Re: Johnson Controls, Inc. (JCI)  
Final Decision and Response to Comments Document,  
MID099124299

Type of Document: Final Decision & Response to Comments

**FINAL DECISION AND RESPONSE TO COMMENTS  
SELECTION OF REMEDIAL ALTERNATIVE  
FOR  
JOHNSON CONTROLS, INC.  
(FORMER STANLEY TOOLS FACILITY)  
FOWLERVILLE, MICHIGAN  
MID 099 124 299**

**FIGURE 2**

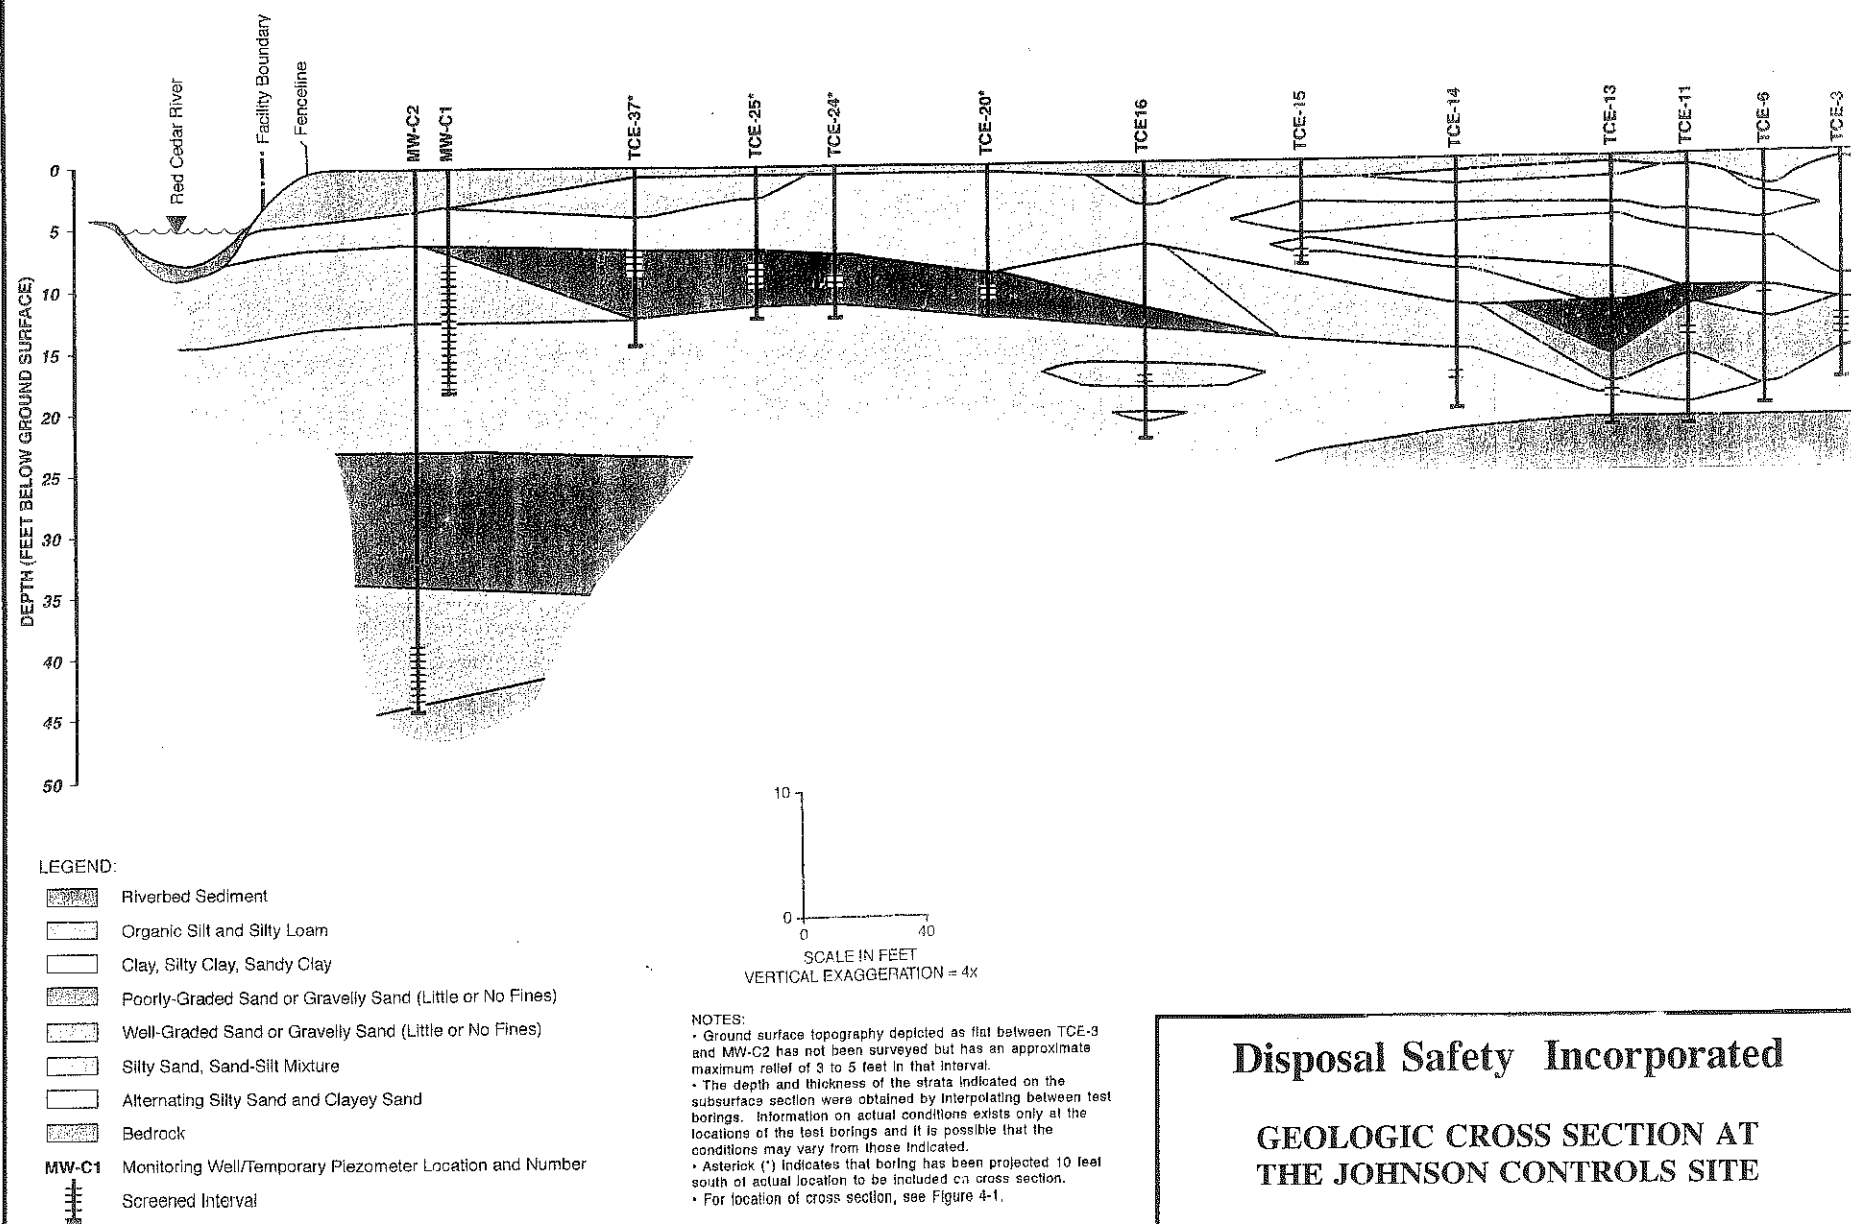
Figure 2, reproduced from the Phase III RFI report, shows a cross section of the geology across the site, oriented along an east-west direction.

**FIGURE 3**

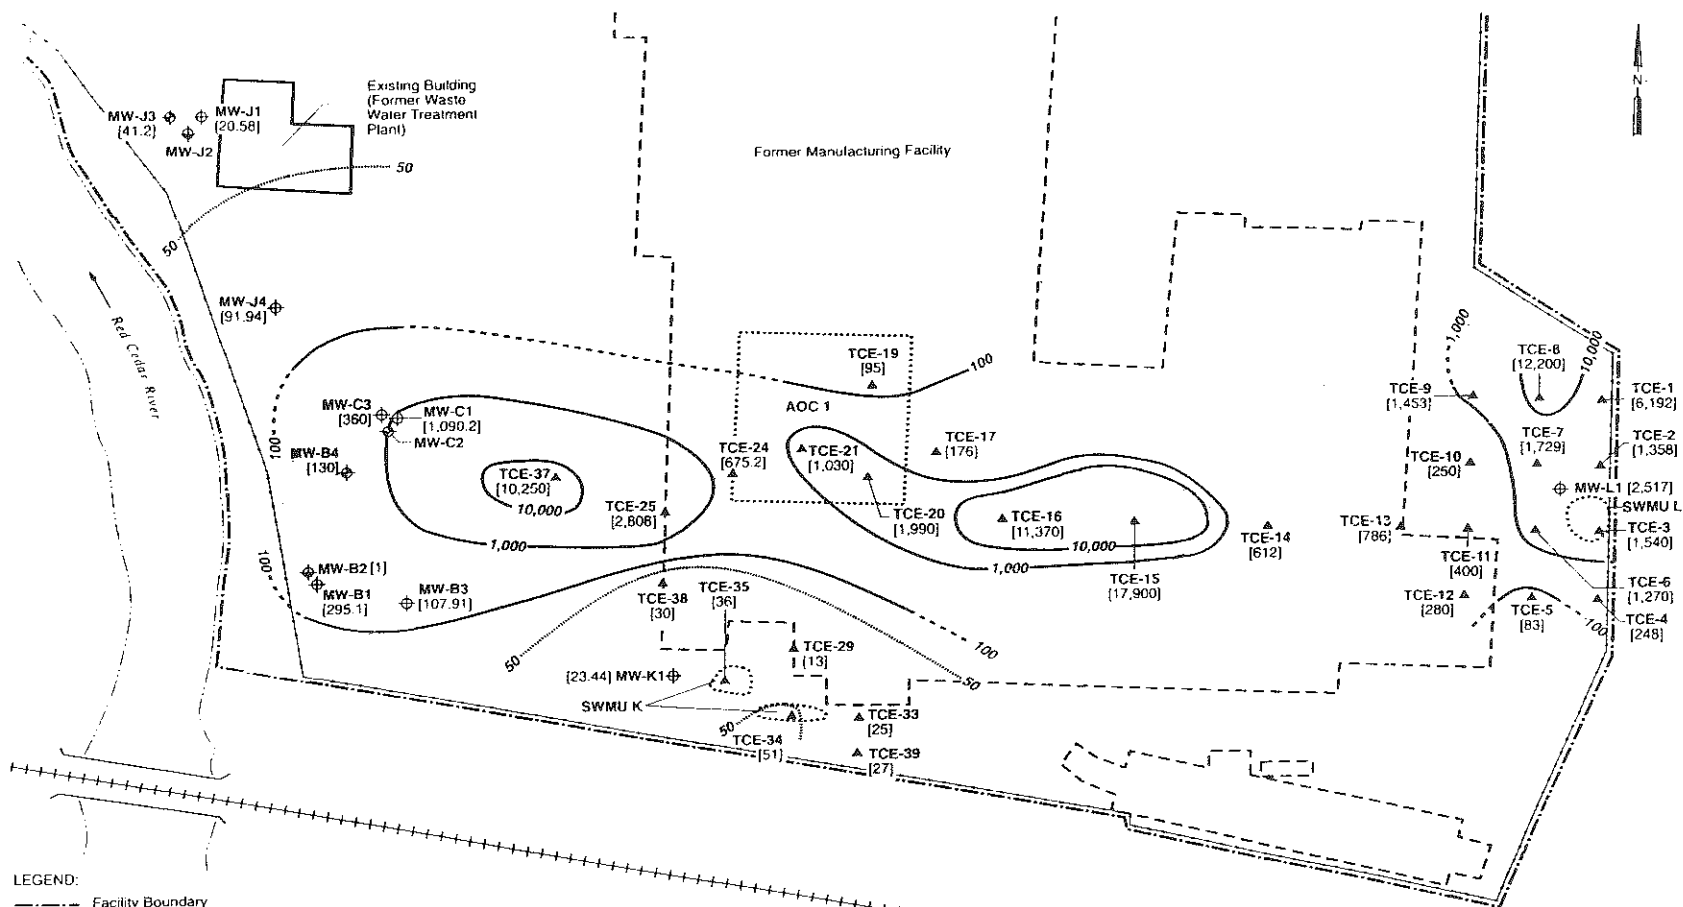
- Johnson Controls drew Figure 5-3 of the Phase III RFI report (our Figure 3) in a way that suggests that little VOC contamination reaches the river. This is misleading. Wells as close as 50 feet from the river contain hundreds of ppb of VOCs, including vinyl chloride. There is little support for drawing, even tentatively, a 100 ppb concentration contour in front of the river.

In Figure 5 we have redrawn JCI's plume map in a way that we believe better conforms to the chemical and hydraulic data. We have opened the 1000 ppb contour north of TCE-9 and TCE-15, and extended the 100 ppb contour to the river.
